University of South Carolina Softball Stadium Construction Columbia, SC

State Project No. H27-6088-MJ Architect's Project No. 11.122.00 Addendum No. 3

ADDENDUM NO.3

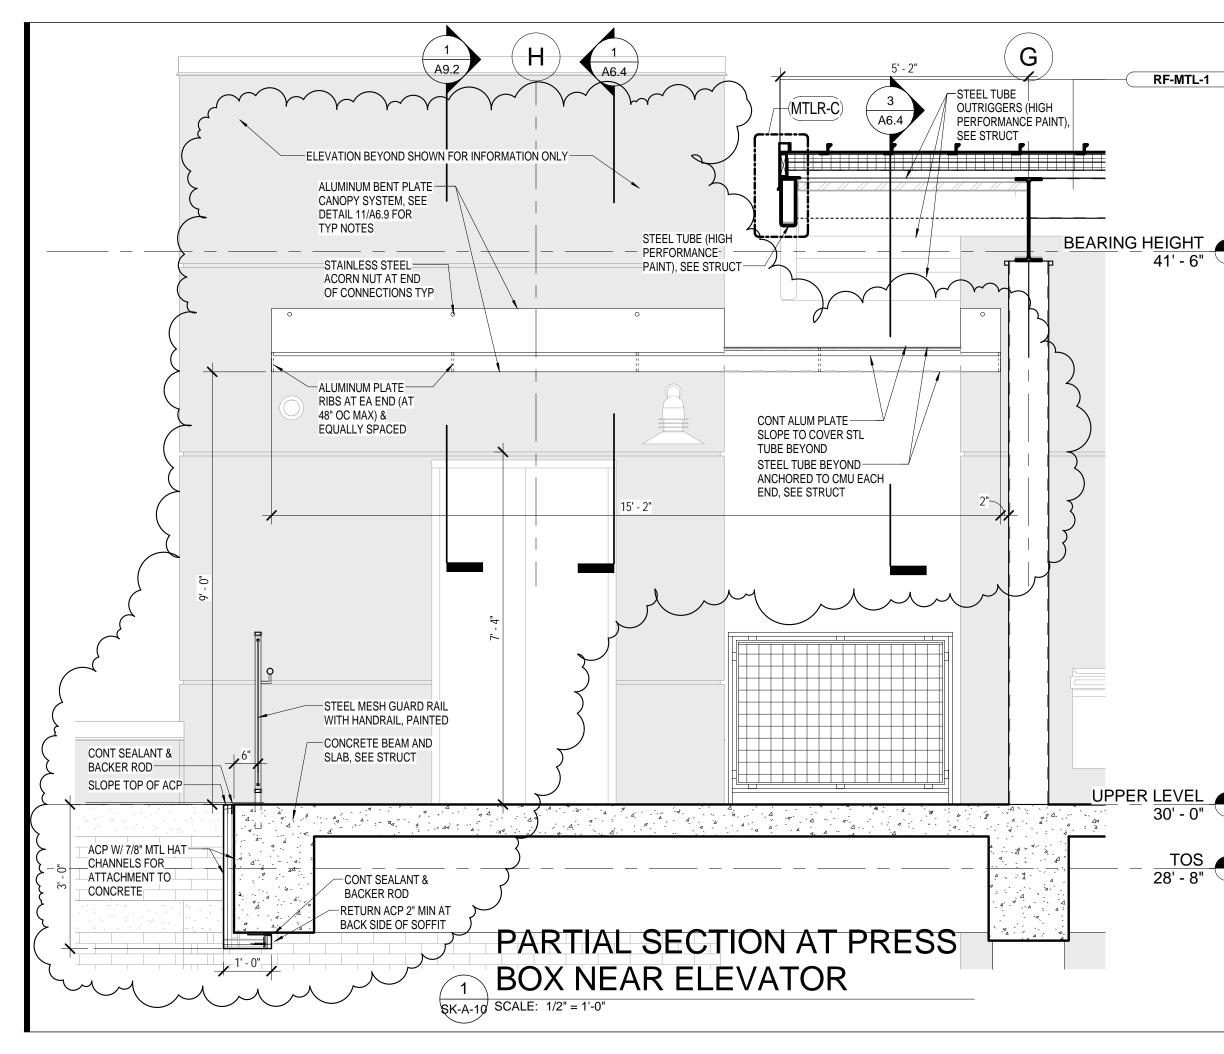
Add Detail 11/A6.9 with sketch SK-A-09 Revise Section 9/A6.9 with sketch SK-A-10 Revise Section 8/A6.9 with sketch SK-A-12 At 6/A6.9, Delete Grout all cavities solid note, Top of footing to be 198.7 and total wall height shall be 10'-8" (field verify final elevations so that wall height is approximately 8'-10" above final elevation of adjacent slab at electrical service area).
